CITY OF WESTMINSTER			
PLANNING APPLICATIONS COMMITTEE	Date 11 October 2016	Classification For General Release	
Report of Director of Planning		Ward(s) involved Abbey Road	
Subject of Report	31 Springfield Road, London, NW8 0QJ		
Proposal	Retention of wraparound dormer.		
Agent	Mr Matthew Black		
On behalf of	Ms Eve Brenner		
Registered Number	16/05956/FULL	Date amended/ completed	12 September 2016
Date Application Received	24 June 2016		
Historic Building Grade	Unlisted		
Conservation Area	St John's Wood

DRAFT DECISION LETTER

Address: 31 Springfield Road, London, NW8 0QJ,

Proposal: Retention of wraparound dormer.

site:	31 SPRINGFIELD RD LONDON NW6 0QJ	drawing:	SIDE ELEVATION
phase:	SURVEY	scale:	1:100@A3
		drawn:	TG
		prepared:	aug '16
		fig. no.:	S-114-006
		rev.:	D
		issued:	09/09,16

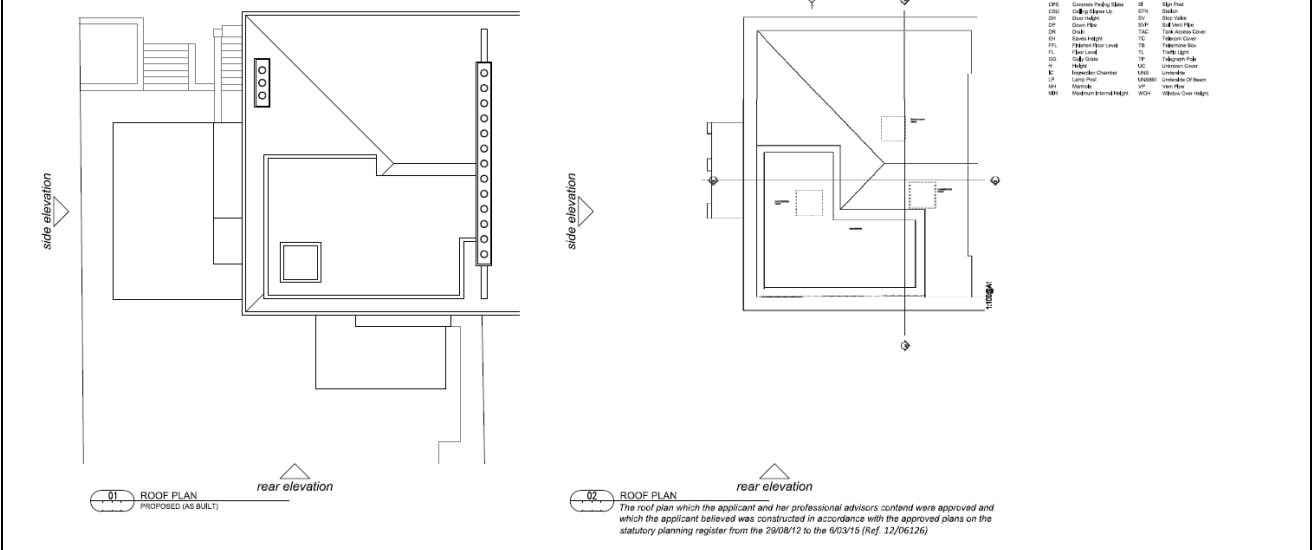
As indicated, the symmetry and balance of nos.31 and 33 Springfield Road is a very positive townscape characteristic and the 'wraparound' dormer harmfully erodes this symmetry at roof level. This impact is most severely evident in views from the rear. In terms of the impact on the individual building, it is a well detailed mid-nineteenth century villa, and its design is based on the principles of Classical architecture, exhibiting order and proportion. The 'wraparound' dormer structure introduces a highly discordant element to the building, largely eradicating the low hipped roof profile to the rear and introducing a bulky roof extension which bears no relationship with the architecture or proportions of the original building.

The 'wraparound' dormer and its impact on the roof profile and symmetry with no.33 is most evident in views from the rear. Views of the dormer can be had from the gardens of neighbouring properties, from within properties on the northern side of Carlton Hill, and from the highway of Carlton Hill, where it can be seen in the gap between nos.30 and 32 Carlton Hill. Thus the harmful impact is appreciable from a number of both public and private vantage points.
